RE: 14341 Browns Lane

I reviewed the drawings, evaluated the neighborhood context and prepared a review letter for staff in June. Substantial changes have been made to a portion of the structure that warrant a second review.. My comments and recommendations on the revised design are as follows:

SECOND FLOOR PLAN: PREVIOUS

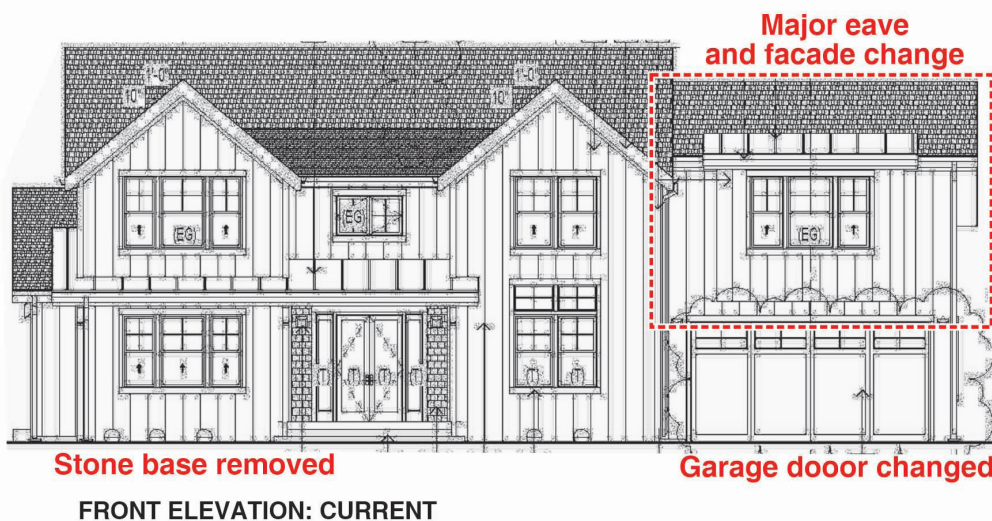
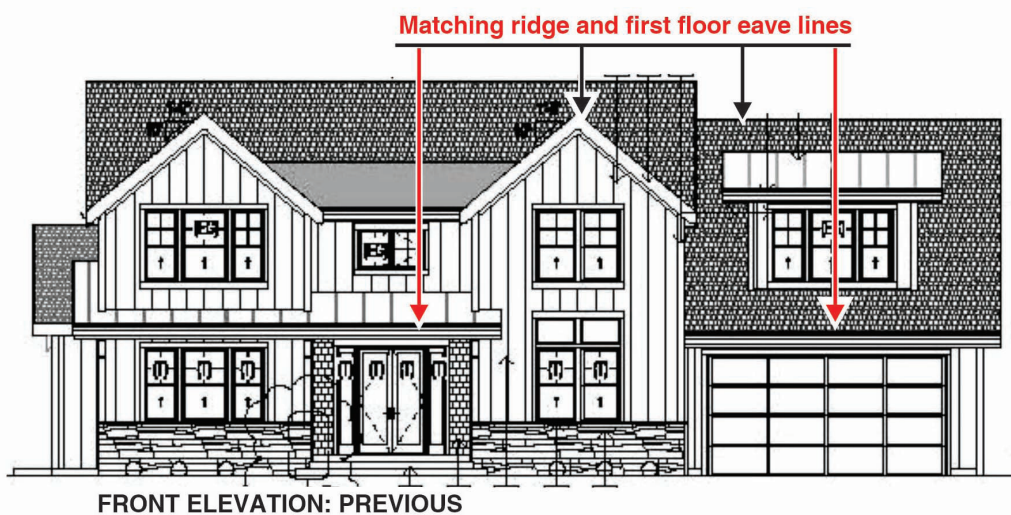
1. The garage and bedroom wing were moved back from the front face of the main house form.

Garage and Bedroom wing
has been moved back and
the interior volume increased.

- The roof slopes for the garage/bedroom wing were changed to a much lower slope than the main roof forms which would not be consistent with Residential Design Guideline 3.5.1.

1. Restore the previously proposed garage/bedroom wing roof slopes and match its ridge and first floor eave heights to those of the main part of the house
2. Widen the roof dormer to provide more interior volume in the bedrooms.
3. Match the dormer roofing material to the nearby main structure roofing.

REAR ELEVATION: CURRENT

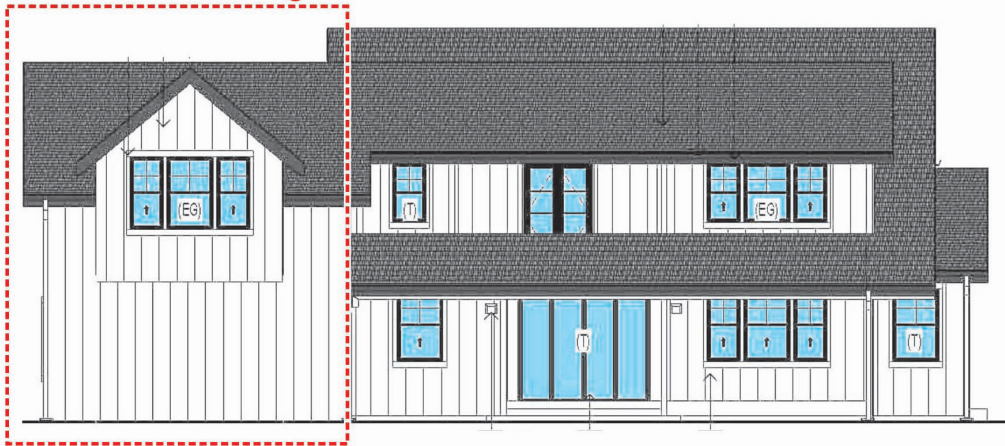
**Major eave
and facade change**

RIGHT SIDE ELEVATION: CURRENT

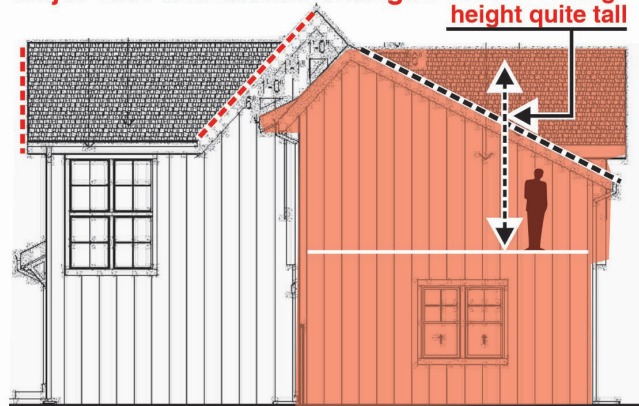
Major roof and facade changes Interior ceiling height quite tall

Roof slopes changed and building extension design is not well integrated to the remainder of the structure

REAR ELEVATION:
RECOMMENDED

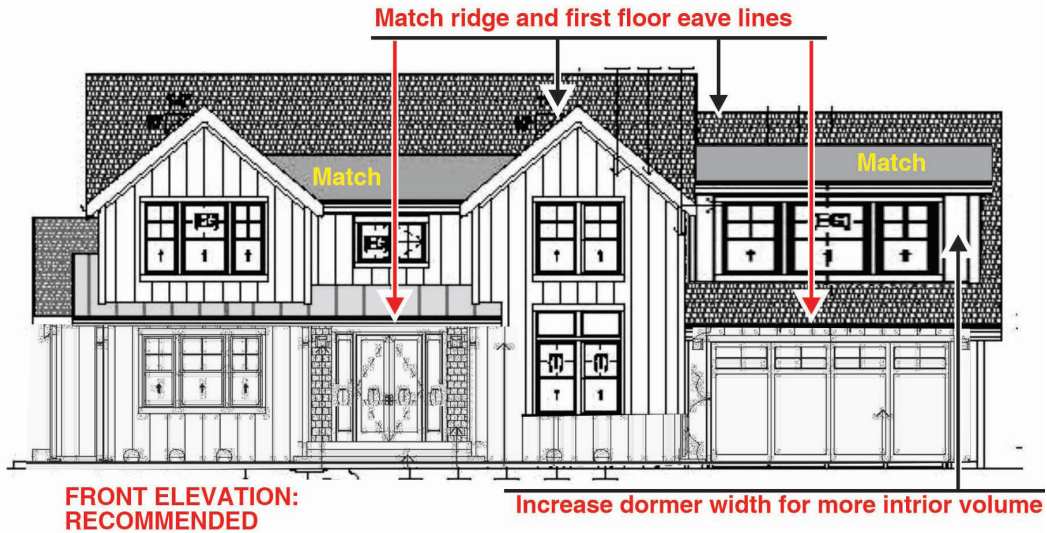
Match recommended front elevation dormer

RIGHT SIDE ELEVATION:
RECOMMENDED

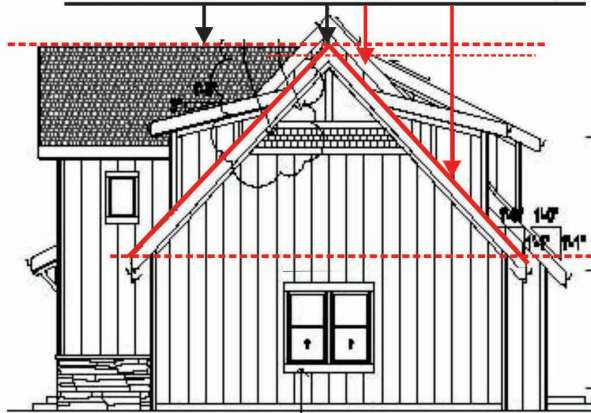
Match front gable ridge height and roof slope
